工程變更客戶通知單

Engineering Change Customer Notification

ECR/ECN 單號： ECR/ECN Number:	EO000270
日期： Date:	2024/09/03
變更者/郵箱： Author/Mail	Paul Liu
客戶端工程變更需求確認：(signature) EC request confirmation by customer	請於 10 工作日內簽回，若超過 10 日未簽回將視為同意此變更 Please sign back within 10 working days, if you do not sign back within 10 working days, you will be deemed to agree to this change.
客戶端工程變更完成確認：(signature) EC completion confirmation by customer	請於 10 工作日內簽回，若超過 10 日未簽回將視為已確認 Please sign back within 10 working days, if you do not sign back within 10 working days, it will be deemed as confirmed.

產品類別 Product Category	零件編號 Part Number
	TGX.08.A.001

4. 變更圖例 Illustration of Change 變更前/Before Accessories don't have pole mount solution.

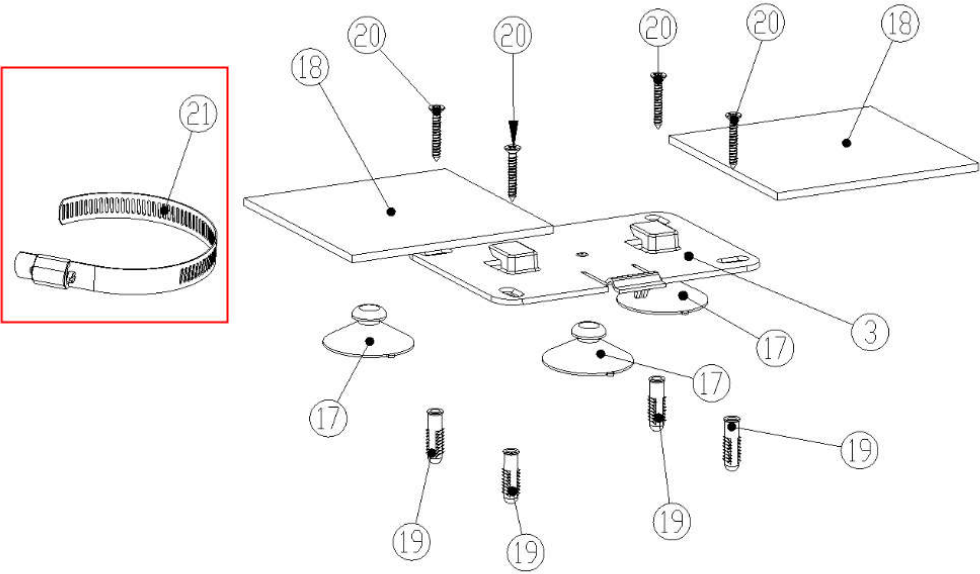
變更類型 Type of Change	<input checked="" type="checkbox"/> 工程設計變更 Engineering Design Change <input type="checkbox"/> 生產製程變更 Production Process improvement	
	<input type="checkbox"/> 其他:	
變更原因 Reason for change	TGX.08.A.001 doesn't have pole mount option.	
變更說明 Description of Change	Add one pieces of hose clamp to the accessories of TGX.08.A.001.	
變更影響 Impact of change	<input type="checkbox"/> 外觀 Appearance <input type="checkbox"/> 功能 Function <input checked="" type="checkbox"/> 規格 Specification <input type="checkbox"/> 品質 Quality <input type="checkbox"/> 可靠度 Reliability <input type="checkbox"/> 法規 Regulations <input type="checkbox"/> 包裝 Package: <input type="checkbox"/> 其他 Others:	
	上述影響描述: Describe if above applies: Yes	Add one piece of hose clamp in the packaging.
預估轉換日期 Forecast Estimated Transition Date	Last buy (old product)	running change
	New buy (new product)	running change

變更後/After
Add one piece of hose clamp in the packaging.

21	Hose Clamp	SUS304	Nature	1
----	------------	--------	--------	---
